# **Monitoring Report MY02**

**Stony Fork Restoration Site  
Upper Neuse River Basin - 03020201  
Monitoring Year 02  
DMS Contract 6830**

## MEMORANDUM

Date: February 24, 2021  
To: Lindsay Crocker, DMS Project Manager  
From: Tim Morris, Project Manager  
KCI Associates of North Carolina, PA  
Subject: MY-02 Monitoring Report Comments  
Stony Fork DMS #6830, Contract 006830  
Neuse River Basin CU 030202018  
Johnston County, North Carolina

N  
 SHEET 1 of 4  
 Source: Google Earth, 2018

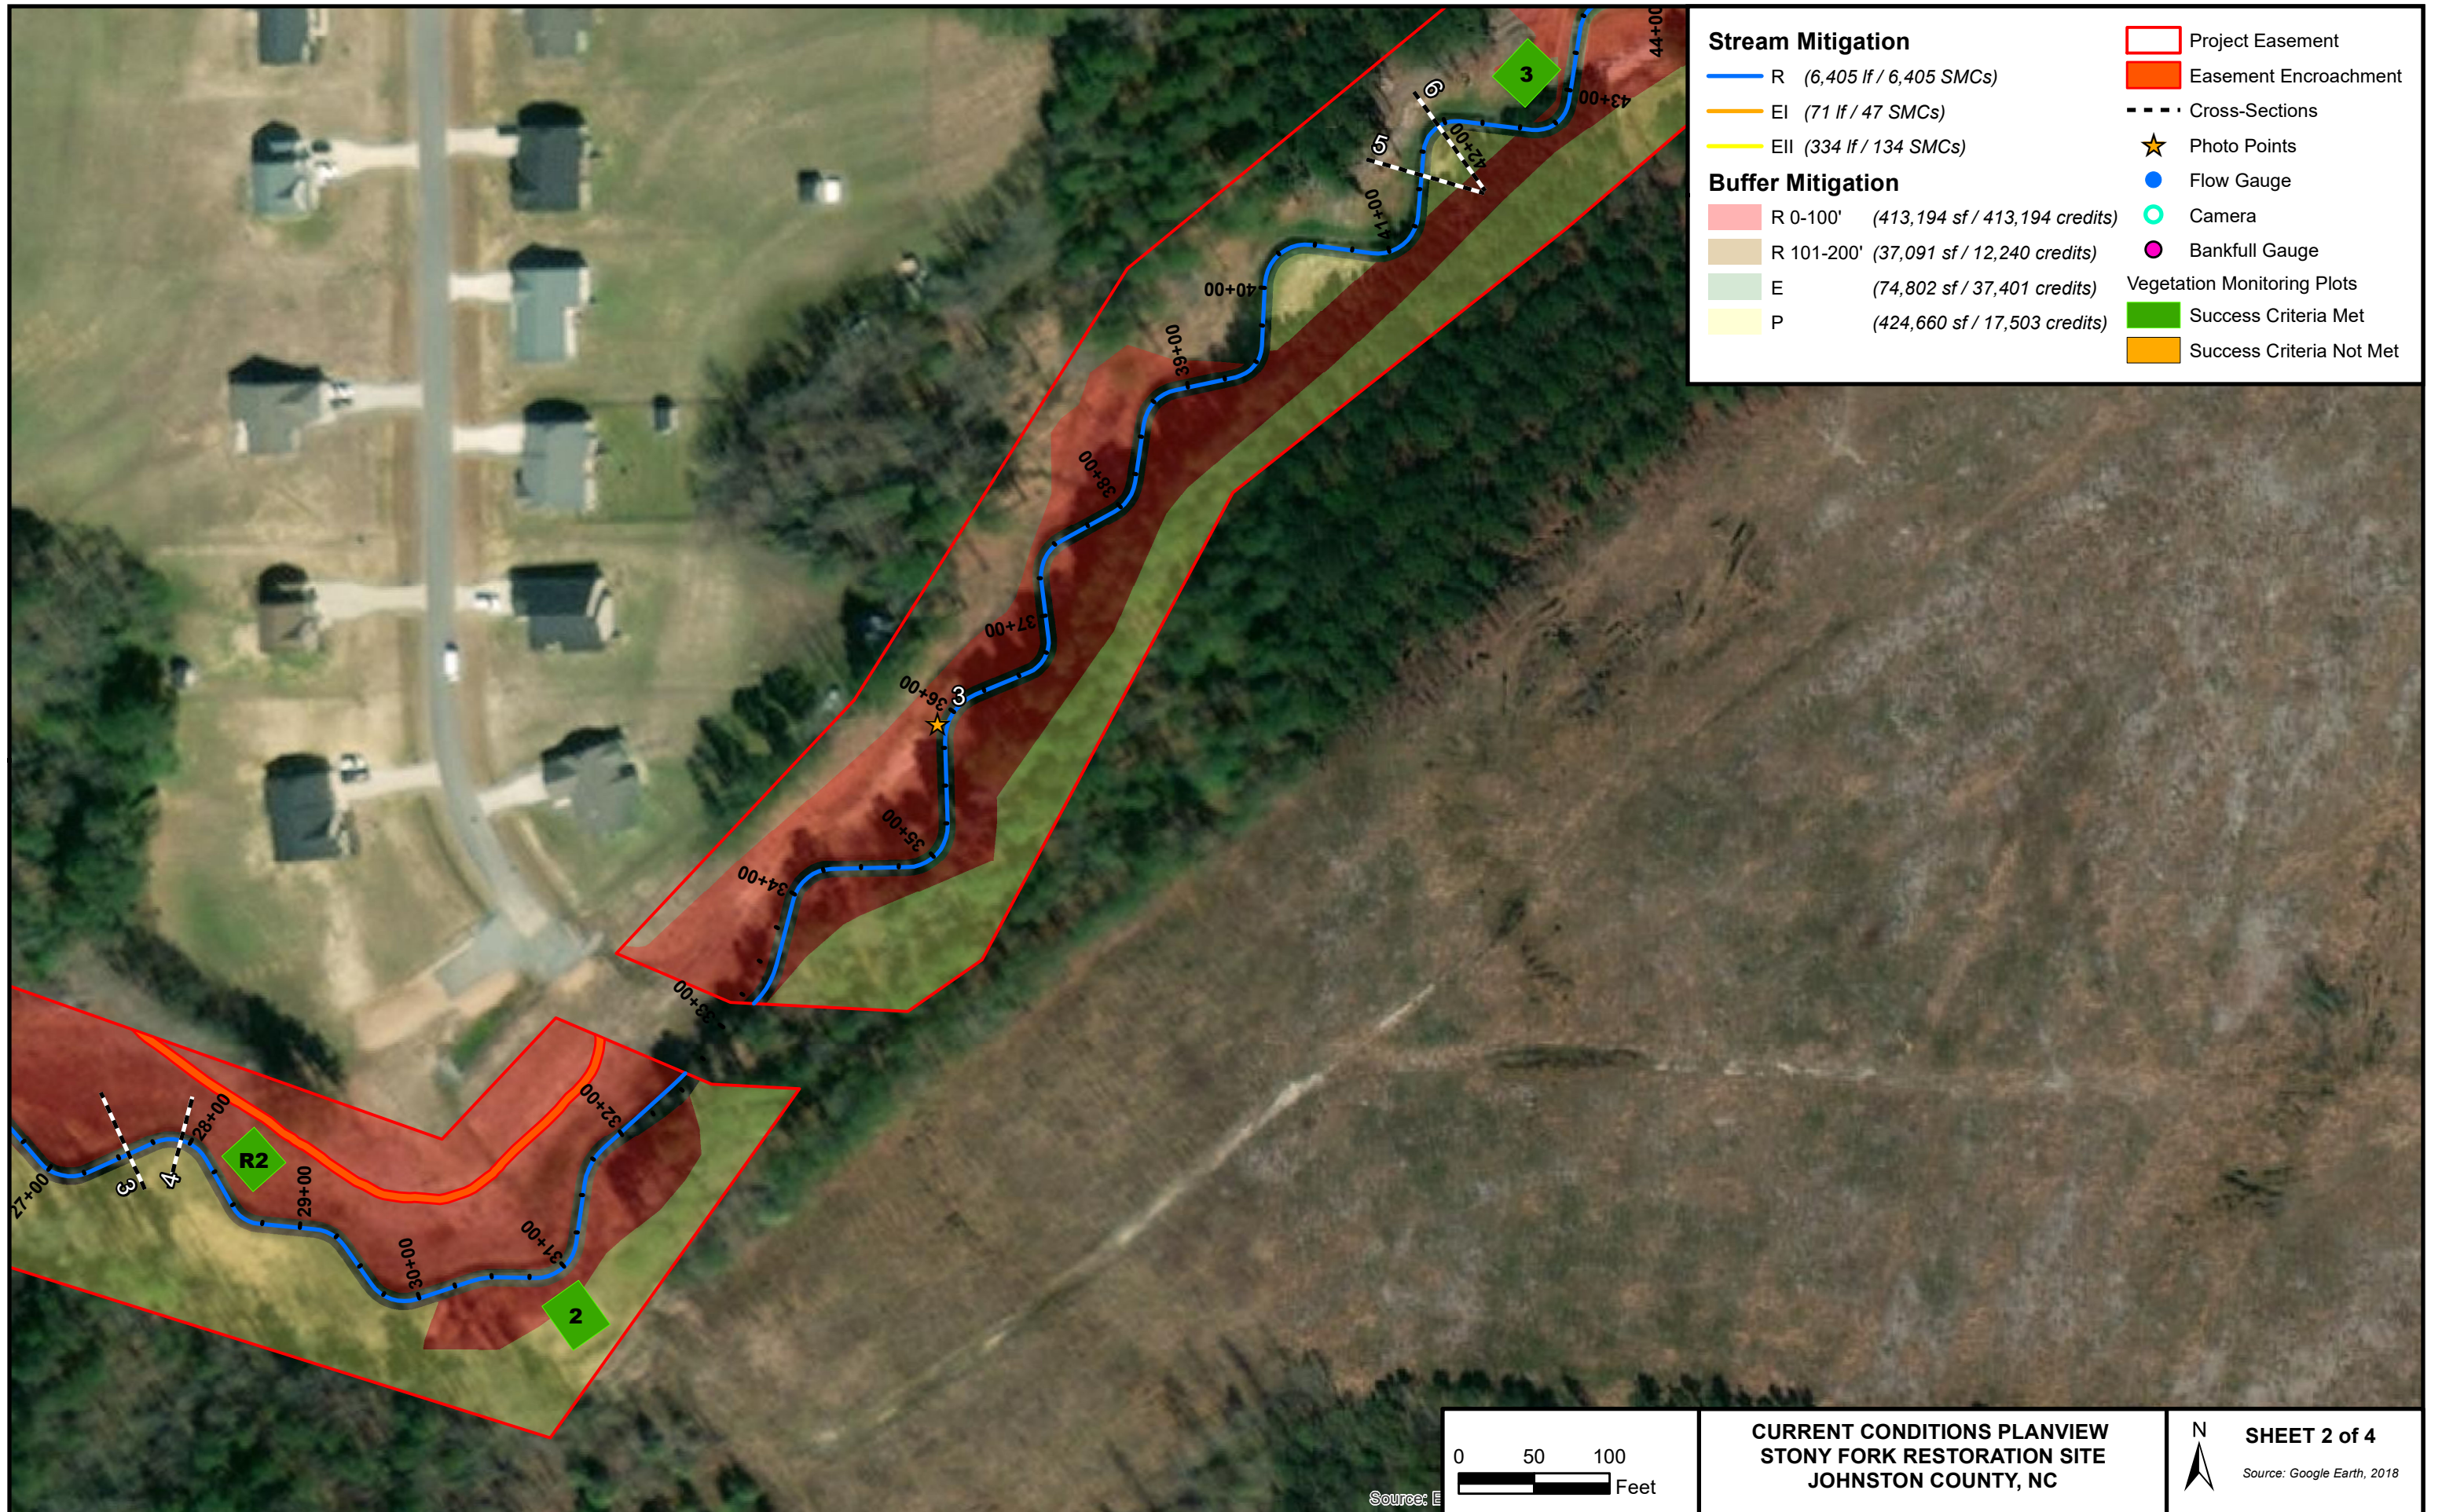
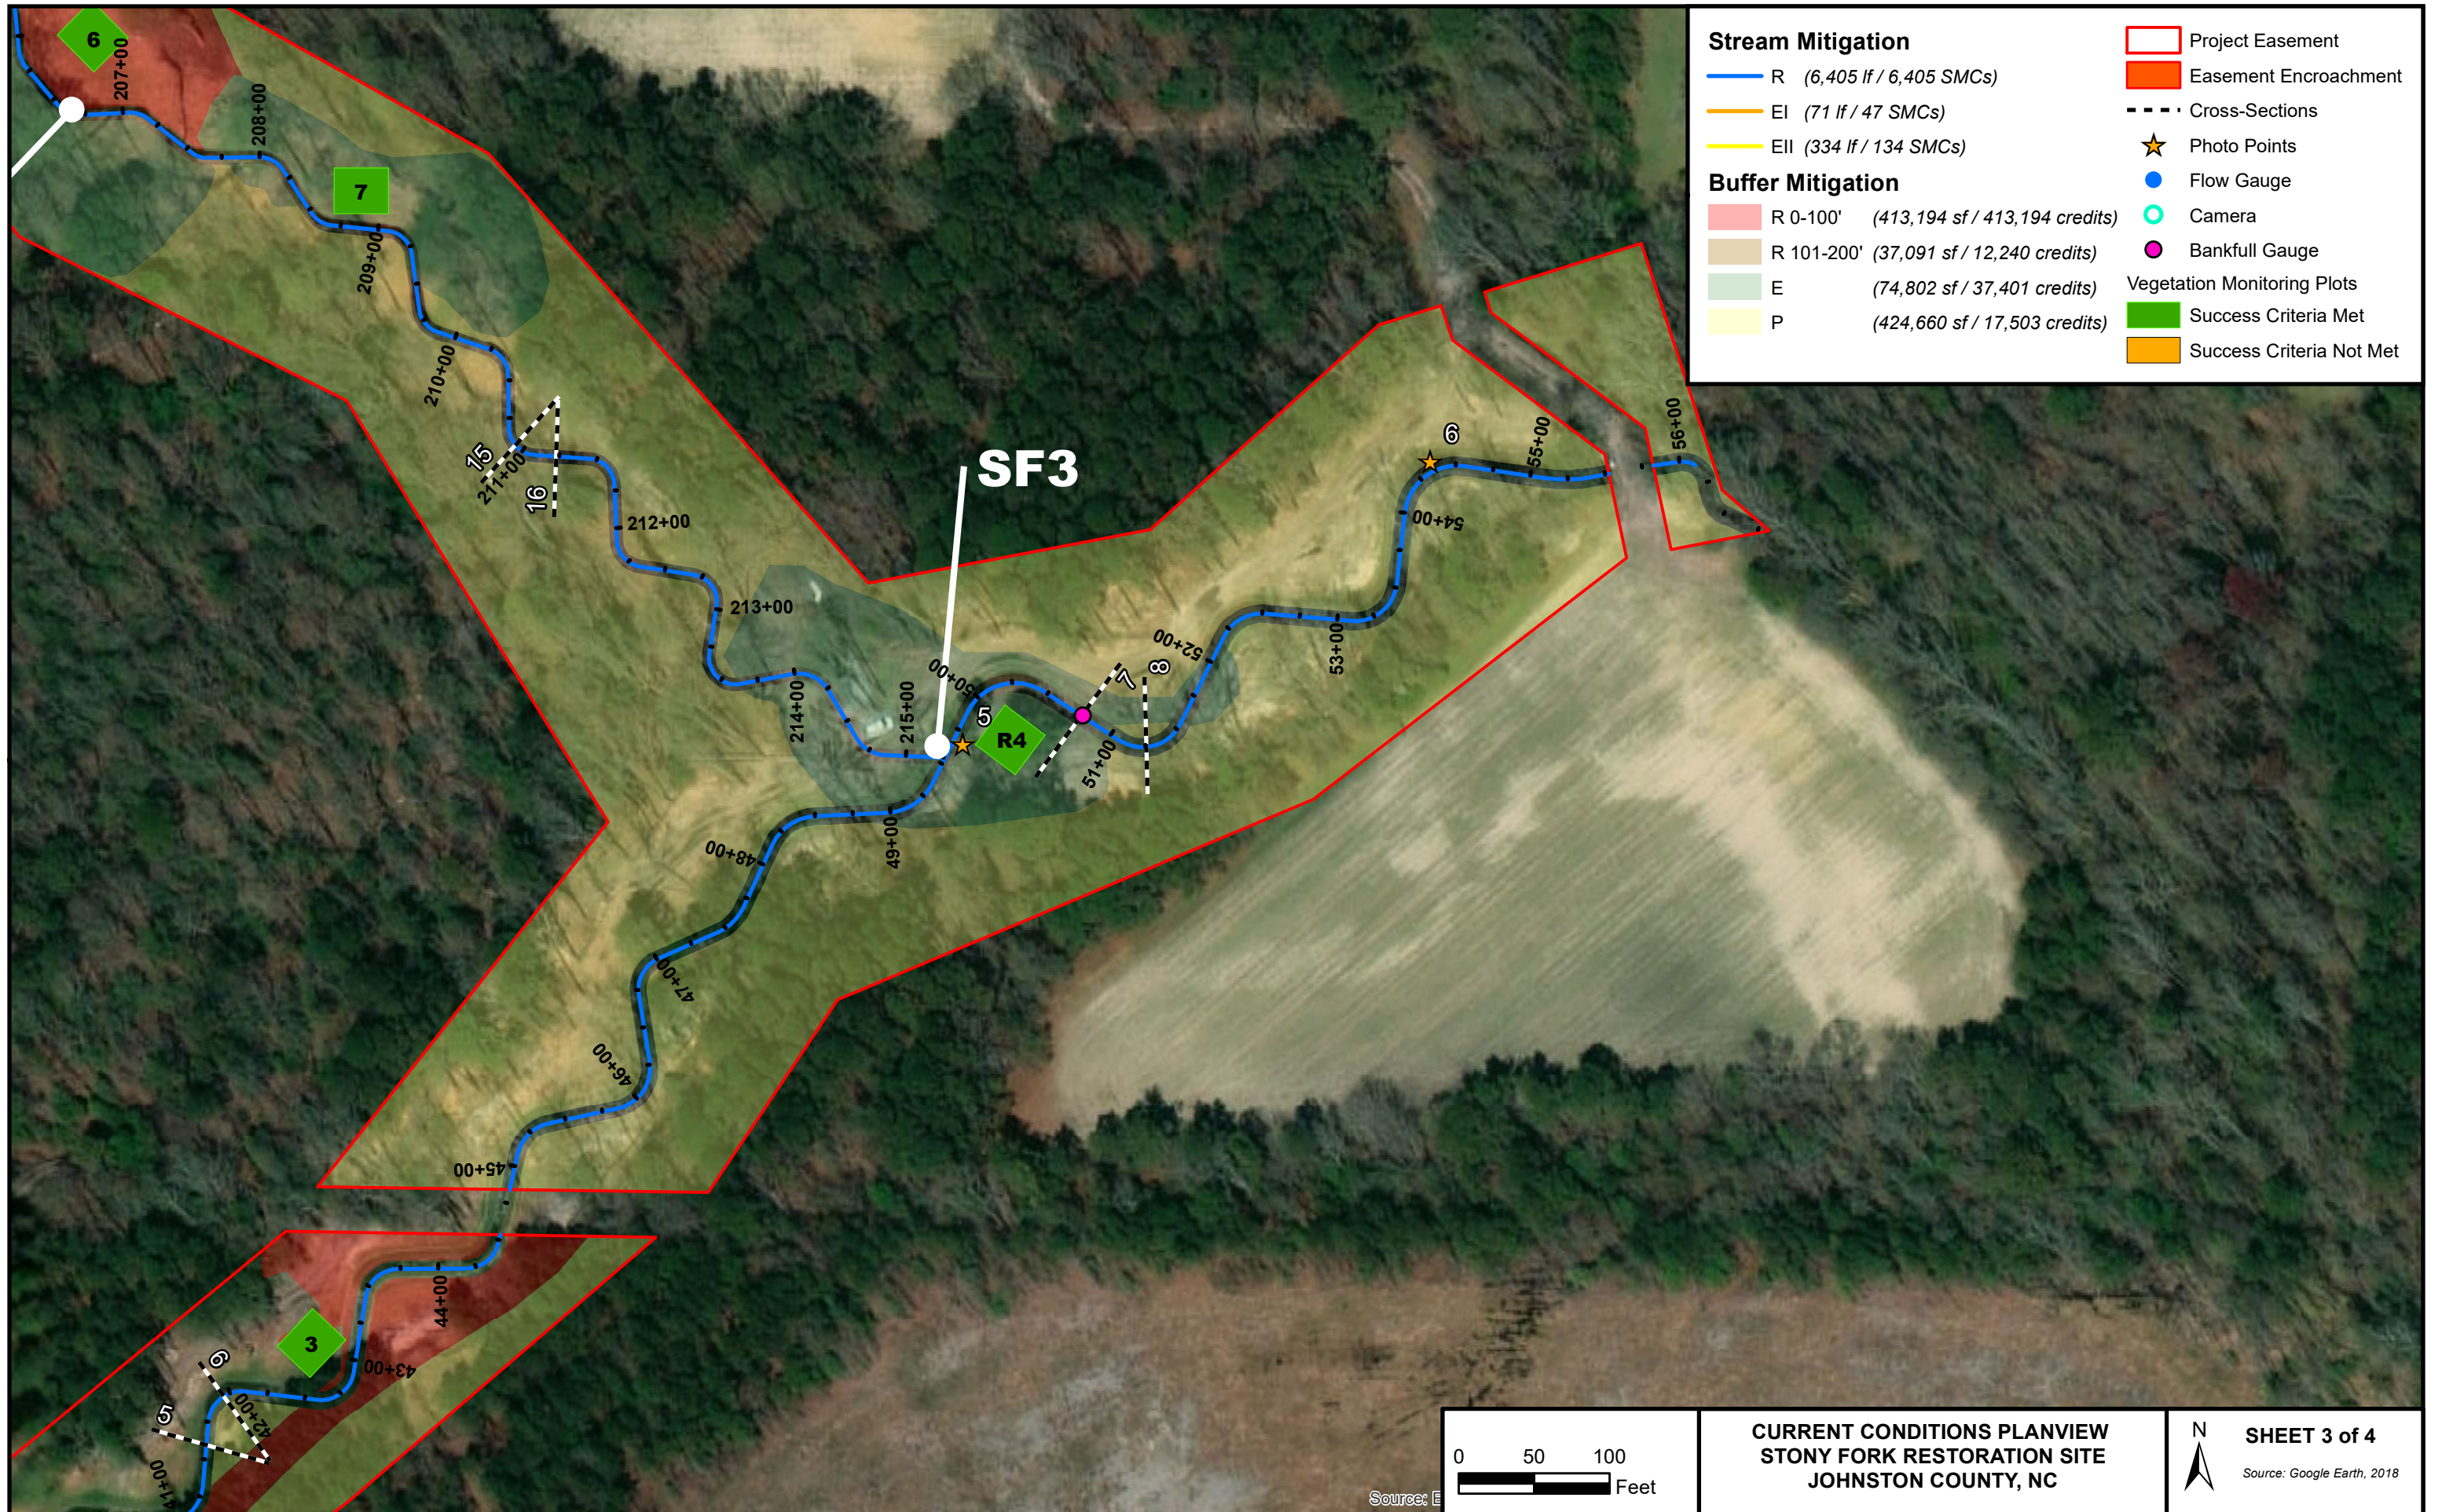
2. Please also document the extent of the encroachment on the CCPV map and measure the area to be reported on the visual assessment table 6 (#5 Easement Encroachment Areas).  
*KCI Response: The extent of the ATV encroachment was surveyed with a handheld GPS on February 9, 2021 and the CCPV and visual assessment table have been updated to show the encroachment.*
